FINAL DRAFT 17 MAY 2022

Draft Campsie Master Plan Site Specific Review

Joint Panel Report

Figure 16: Option D – Ground Floor Plan

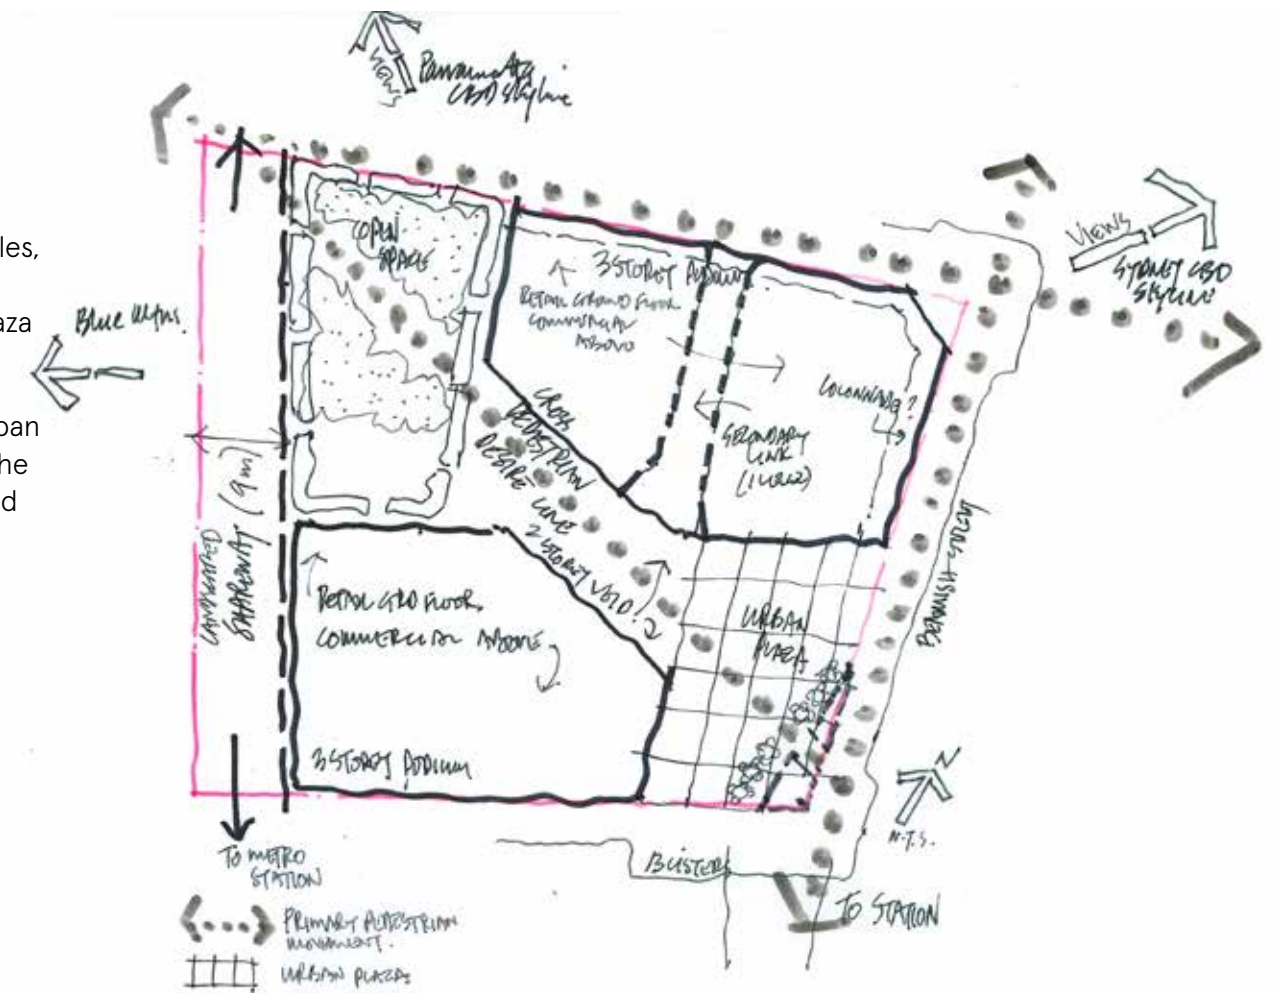
After considering these different options, and in the interest of broadening an understanding of potential approaches, the Panel identified a further potential option. This "Option D" would see built form reinforce the street corner, a 3-storey podium forming street-walls with an urban plaza to the south east corner and a single tower (800m²) in a generally north south orientation parallel to Beamish Street and Ninth Ave. Refer to Figure 16 and Figure 17.

A three storey street wall (to all street frontages and a new urban plaza) is consistent with the maximum street wall height contemplated in the draft Master Plan. It would also support increased floor space for employment generating uses, noting that is one of the key principles of the draft Master Plan, to support and catalyse growth of Campsie as a strategic centre. Furthermore, a three storey street wall is an appropriate design response on this site which occupies an entire city block. It would define the street edge at a scale consistent with other main street development and, relative to a lower street wall, would be more effective at diminishing the visual impact of the tower in views from Beamish Street and a new urban plaza.

Taking into account all design considerations, site analysis and Council's testing, the Panel consider that the draft Master Plan maximum FSR control can be increased from 4.5:1 up

to a maximum of 4.9:1. Development up to this maximum would enable an optimal development outcome which is consistent with other draft Master Plan controls and principles, is appropriate in the context and includes the potential for additional public benefit in the form of new public urban plaza addressing Beamish Street.

Figure 24: Section showing solar and visual impacts on Anglo Road Properties

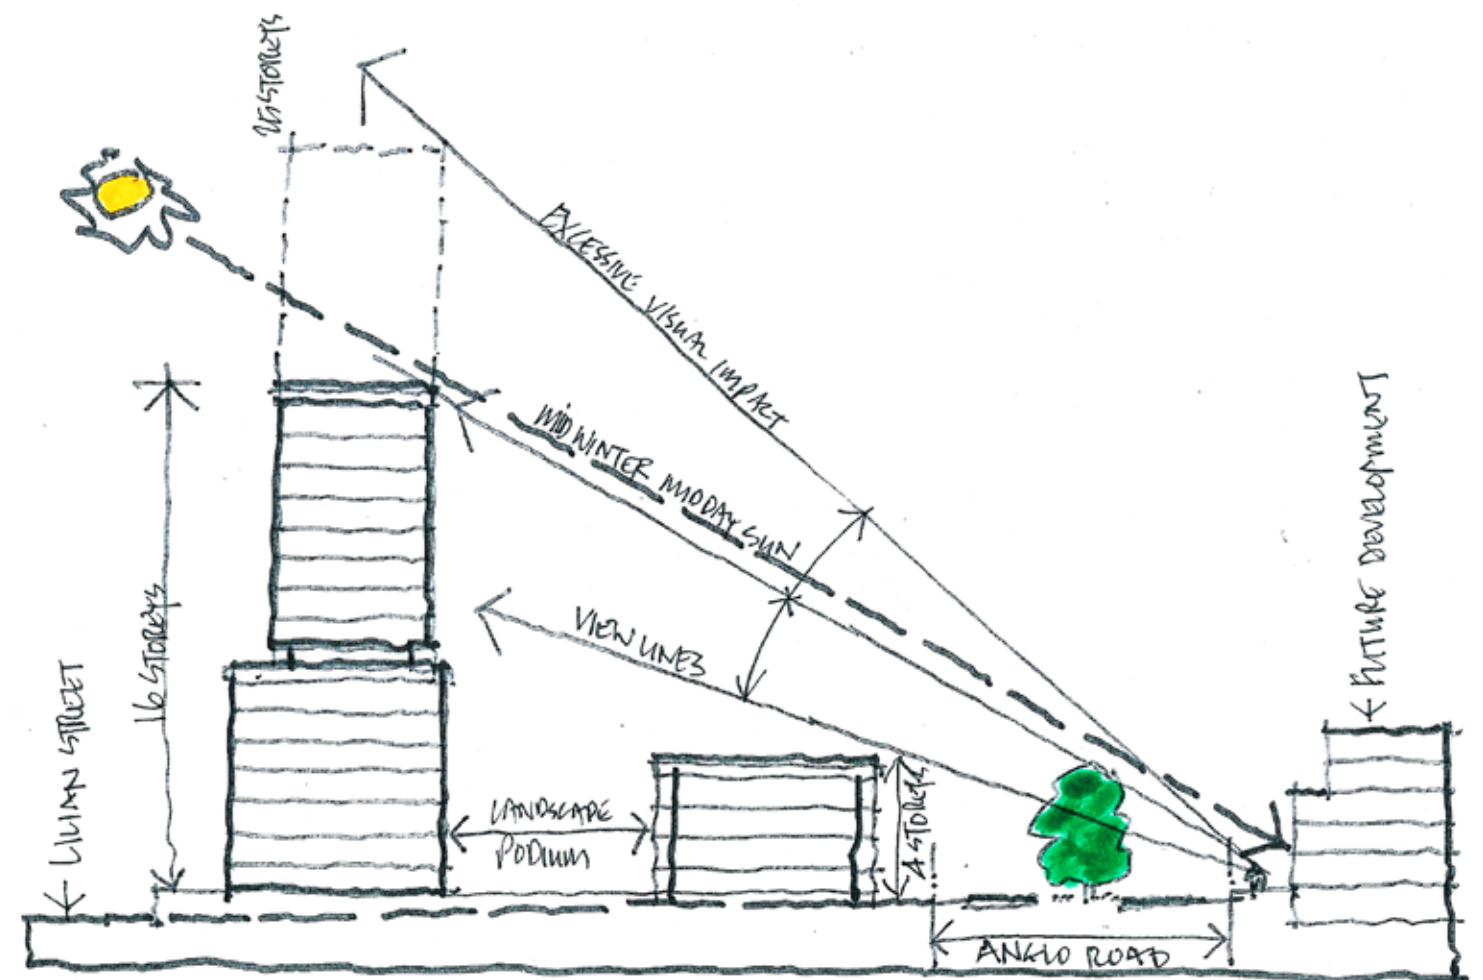
The proposal demonstrates acceptable overshadowing impacts for Anzac Square, Carrington Square and surrounding streets. However, the proposed 25 story tower would result in shadow impacts for future development to the south side of Anglo Street which the draft Master Plan seeks to avoid.

The modelling confirms that the Panel's preferred built form outcome can be achieved with the 3.2:1 FSR currently proposed in the draft Master Plan. There is potential to take better advantage of the incentive floorspace provisions for underground space and address urban design issues, as outlined below.

A higher building may be possible in the north-east corner of the site (west of the laneway) The proposed 4 storeys could potentially reach 8 storeys. If this approach were pursued the building length along Lilian Street would need to be addressed in design development.

Figure 25: Built form with defining edges to ANZAC Park and active frontage

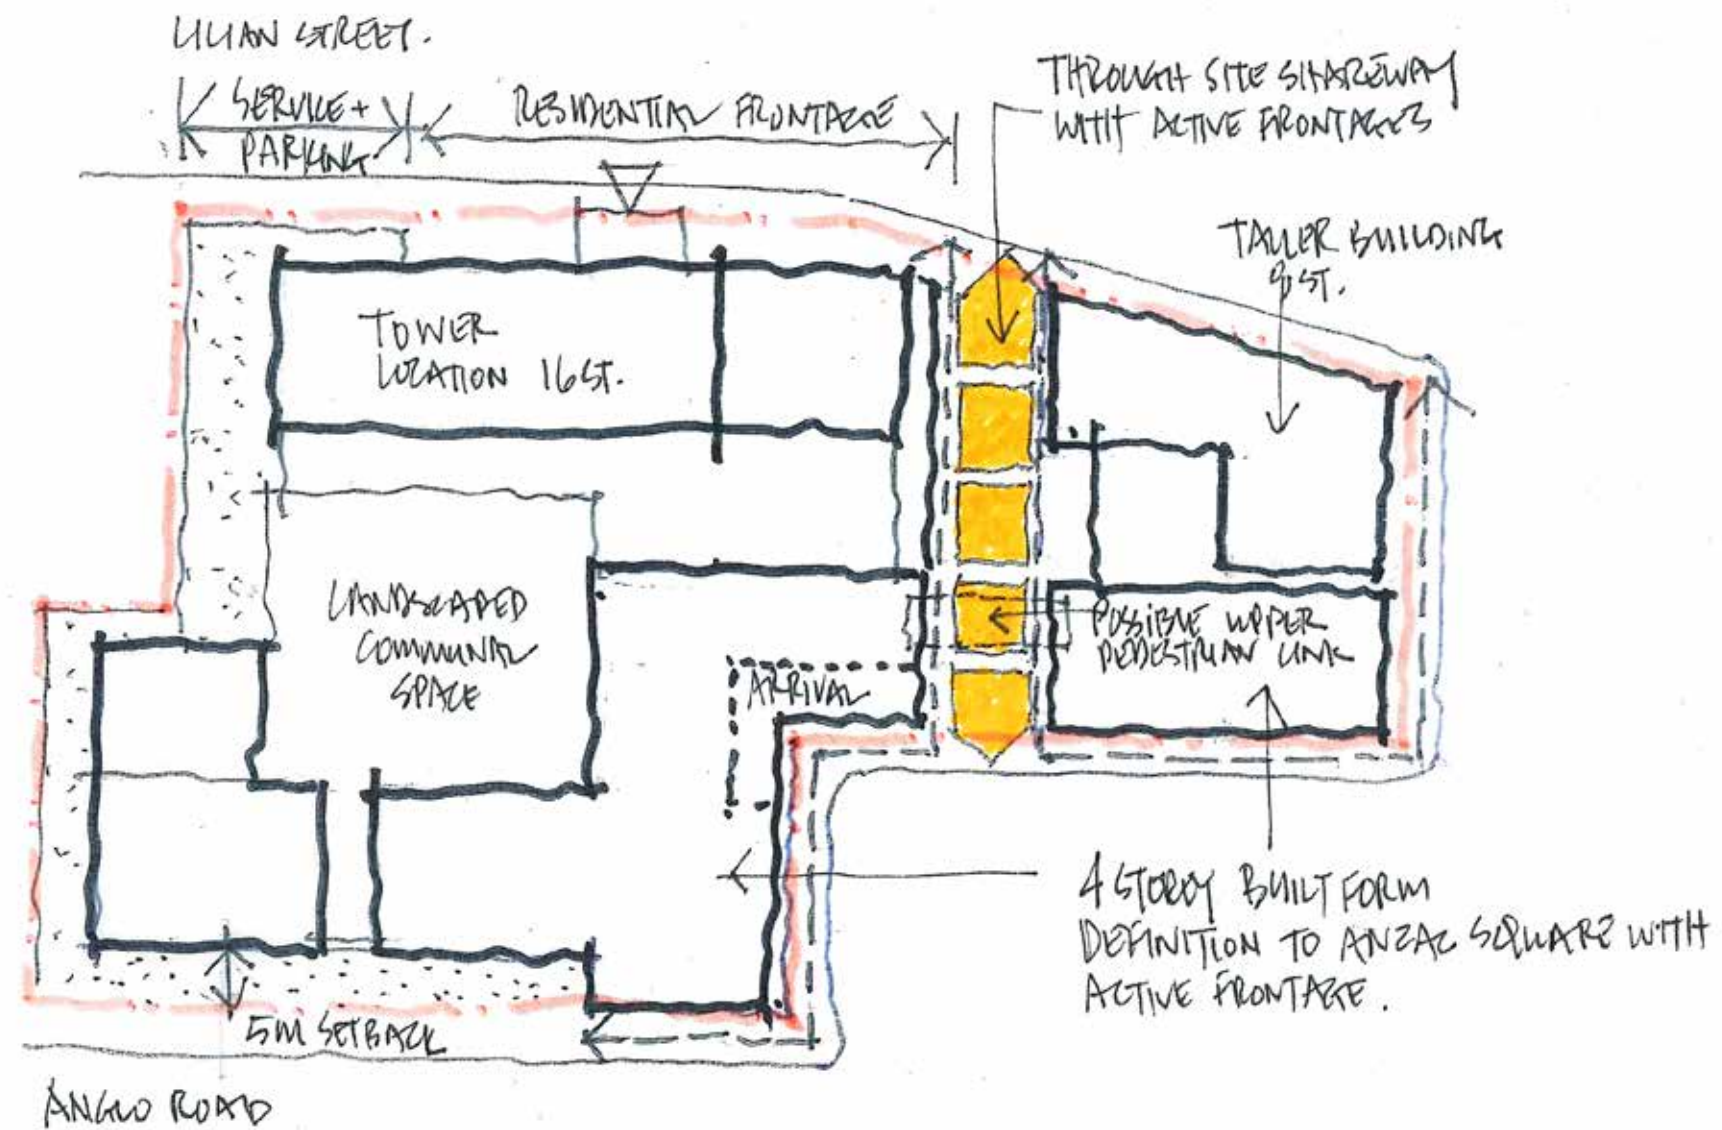
Despite these commercial factors, this approach limits preferred built form and urban design outcomes for the site. A more holistic approach to redevelopment may provide the opportunity for:

- a 4 storey street wall to Anzac Park, for more consistent building edge to the park, consistent with the draft Master Plan;
- relocation of some or most of the Club floor area below ground, providing for a greater yield, consistent with the intent of the draft Master Plan; and
- a more considered approach to activating the Dewar and Lilian St frontages, refer to Figure 25.

Figure 31: Ground floor plan showing recommended setbacks and key links

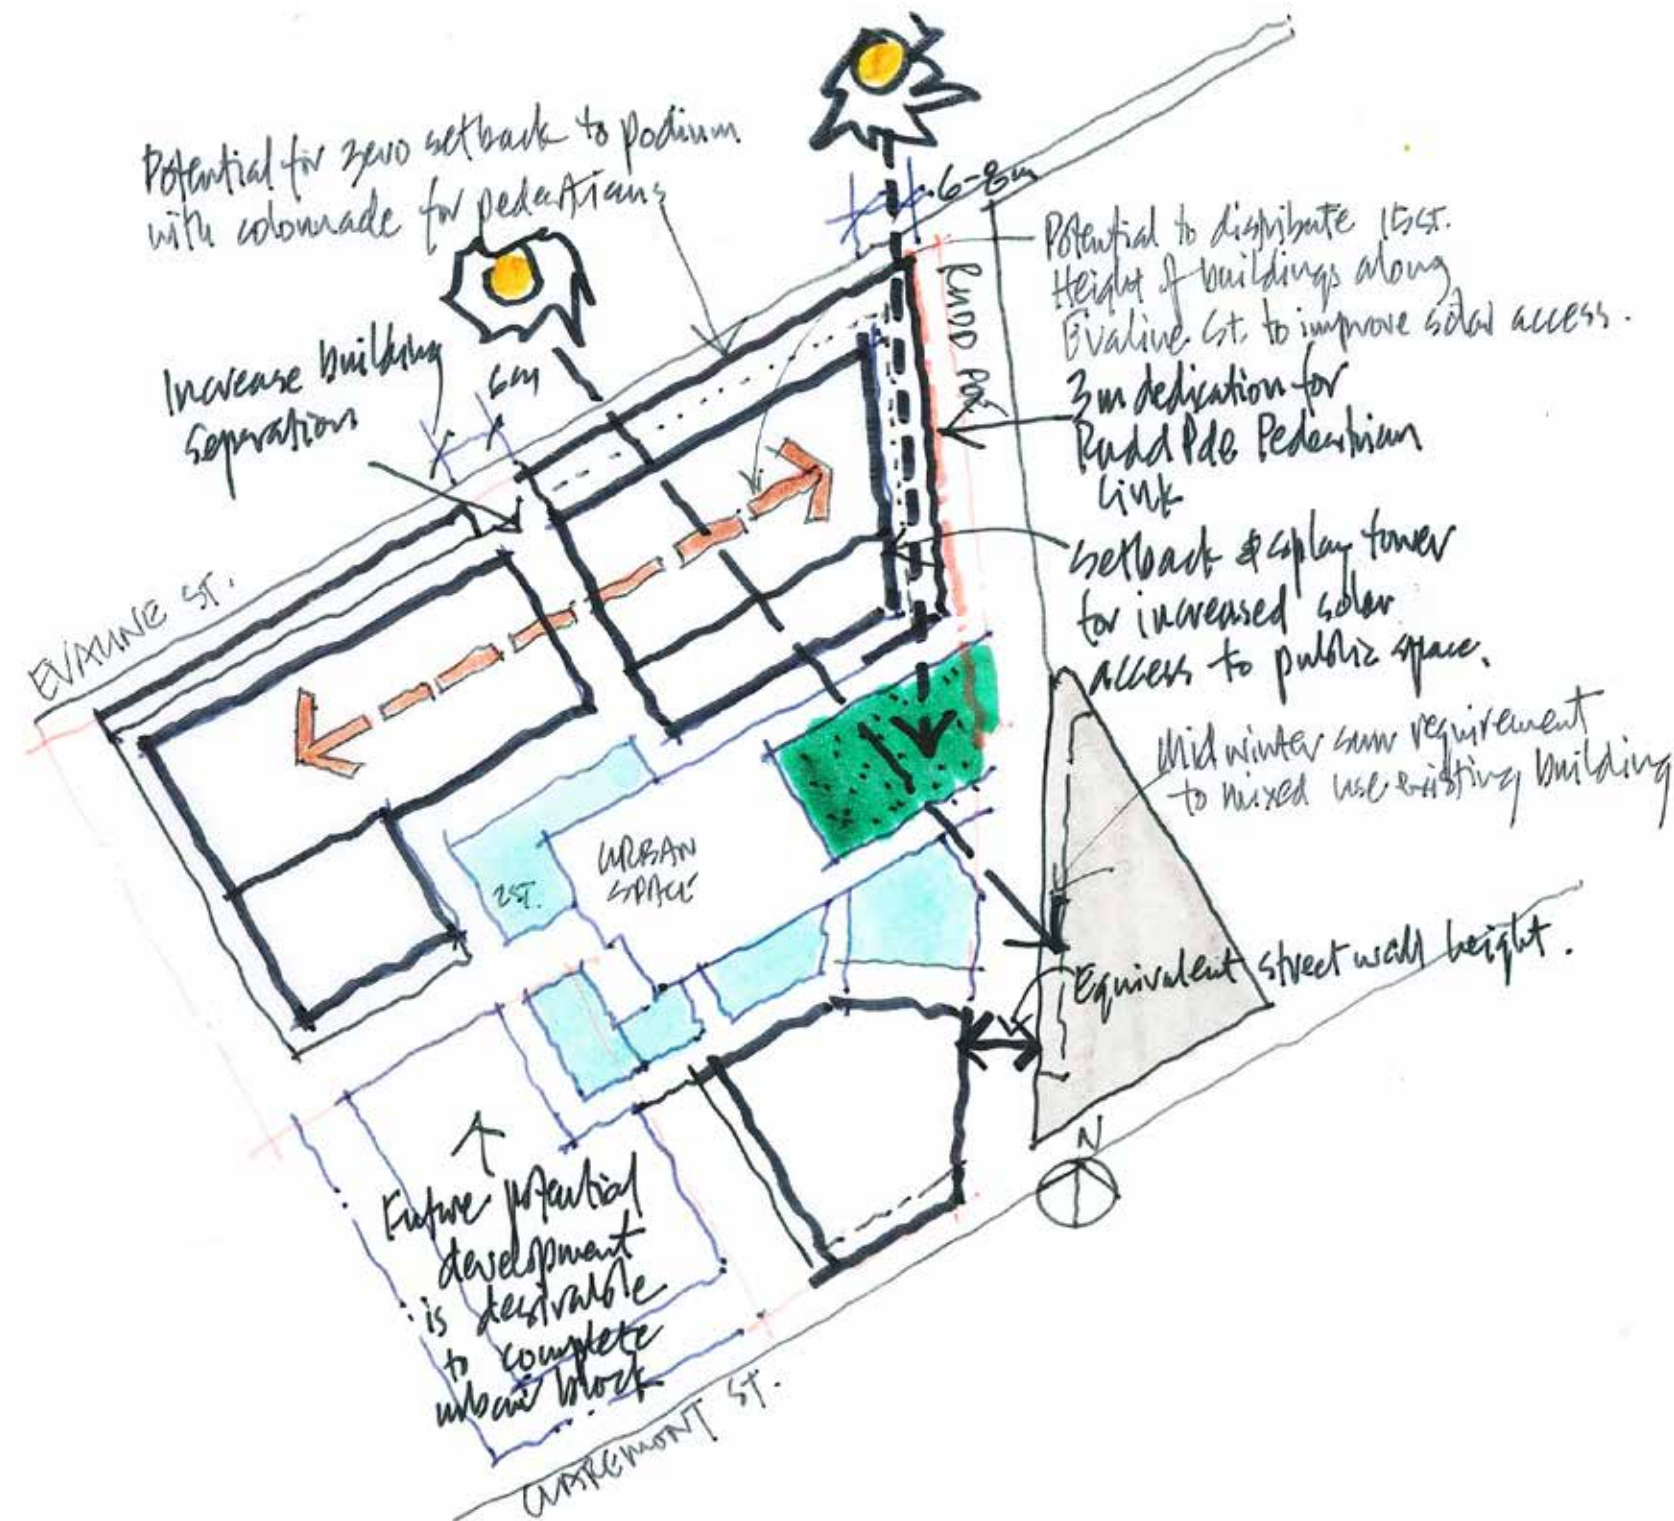
The overall scheme has well considered urban design merits. It would be considerably enhanced by inclusion of the three adjacent sites to the west on Claremont Street. A more regular block and built form would then define the south-west corner and provide better enclosure of the proposed central urban space.

There are substantial Plane trees along Rudd Parade near Evaline Street. Adequate setbacks from these trees should be examined together with the potential for the proposed deep soil zones to protect existing trees on site.

The Panel recommend modifying the draft Master Plan height control to allow for a 15 storey tower to be located anywhere along the Evaline Street frontage to optimise solar access to the urban space and adjacent development. Related floor plate and built form separation controls are recommended to control building bulk while providing maximum flexibility during design development. The 3m building separation between the 15 and 8 storey buildings fronting Evaline Place is inadequate. It should be a minimum of 6m to improve airflow, noting that compliance with SEPP 65 and the ADG may require greater separation at development application stage.

- existing and future potential development adjacent and south of the site's boundaries; and
 - the proposed internal urban space, noting the draft Master Plan requirement for solar access.

- Provide a minimum 6m separation between the tower and lower built forms fronting Evaline Street.
- Dedicate a 3m wide strip of the north eastern corner of the site (total of approx. 180m²) for a consistent 6m width to Rudd Parade.

The above recommendations are shown in Figure 31

Figure 39: Recommended setbacks

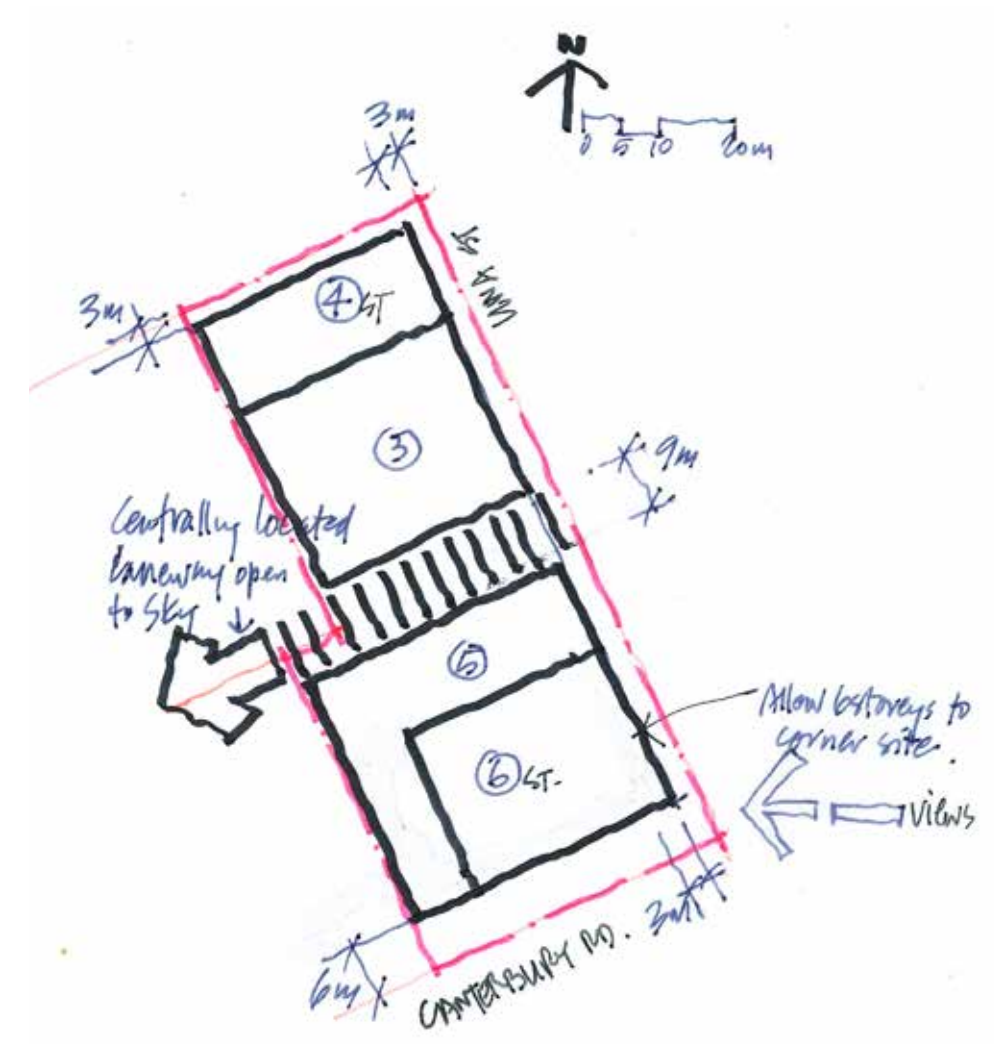
Residential uses are prohibited in the B6 zone which encourages a range of commercial and employment generating uses, particularly those with a medical focus. The Panel agrees with this direction of the Master Plan and does not support the proposed introduction of residential uses on this site.

A continuous centrally located laneway open to the sky is considered essential to service commercial uses fronting both street and to break up the scale and built form of development within the block.

In terms of built form the Panel considers that this corner site can support 6 storeys to Canterbury Road and 4 Storeys to Perry Street. This will strengthen and 'bookend' the large corner site, without disrupting a step up in height through to Beamish Street. It also provides some variety and massing modulation of the form of buildings addressing the streets. The Panel's recommendation for a minor increase to the FSR responds to this modified built form.

- Retain existing B6 Enterprise Corridor zoning
- Allow FSR of 2.0:1 (south of laneway) and 1.5:1 (north of laneway).
- Maintain 6m setback to Canterbury Road, consistent with approach along this length of the corridor.
- Retain street setbacks as per draft Master Plan
- Allow heights of:
 - 6 storeys on the corner of Canterbury Road and Una Street, stepping down to 5 storeys to address the site's western boundary and central laneway; and
 - a majority of 3 storeys for the part of the site north of the central laneway, stepping up to 4 storeys on the Perry Street frontage.

Refer to Figure 39.
